## PIC16C77 Rev. A Silicon Errata Sheet

The PIC16C77 (Rev. A) parts you have received conform functionally to the Device Data Sheet (DS30390E), except for the anomalies described below.

## Clarifications/Corrections to the Data Sheet:

In the Device Data Sheet (DS30390E), the following clarifications and corrections should be noted.

**FIGURE 1: WRITES TO TIMER1 (EXTERNAL CLOCK/OSCILLATOR MODE)**

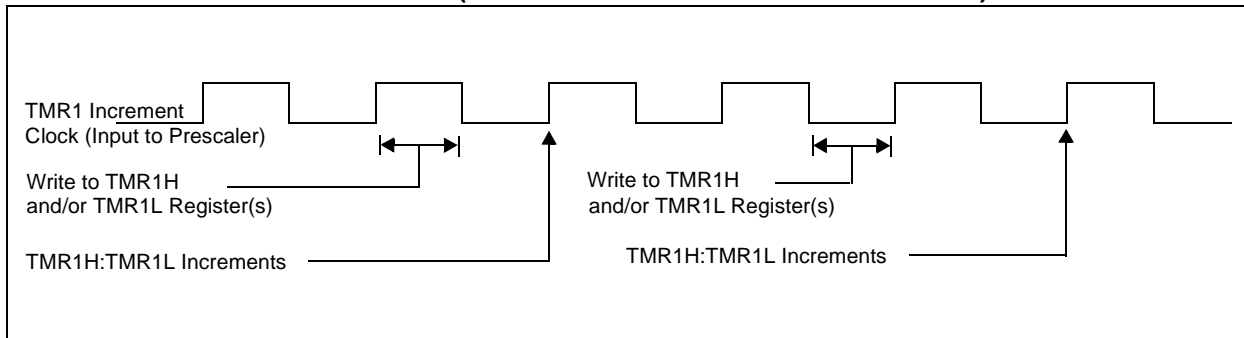
## 4. Module: Timer1

The operation of Timer1 needs some clarification when the timer registers are written when the TMR1ON bit is set.

The internal clock signal that is the input to the TMR1 prescaler affects the incrementing of Timer1 (TMR1H:TMR1L registers and the Timer1 prescaler). When the Timer1 registers are NOT written, the Timer1 will increment on the rising edge of the TMR1 increment clock.

When the TMR1H and/or TMR1L registers are written while this clock is high, TMR1 will increment on the next rising edge of this clock.

When the TMR1H and/or TMR1L registers are written while this clock is low, TMR1 will not increment on the next rising edge of this clock, but must first have a falling clock and the rising clock, for TMR1 to increment.

Figure 1 shows the two cases of writes to the TMR1H and/or TMR1L registers. Due to the V<sub>IH</sub> and V<sub>IL</sub> thresholds on the oscillator/clock pins, external Timer1 oscillator components, and external clock frequency, the Timer1 increment clock may not be of a 50% duty cycle.

The TMR1 increment clock is out of phase of the T1OSO/T1CKI pin by a small propagation delay.
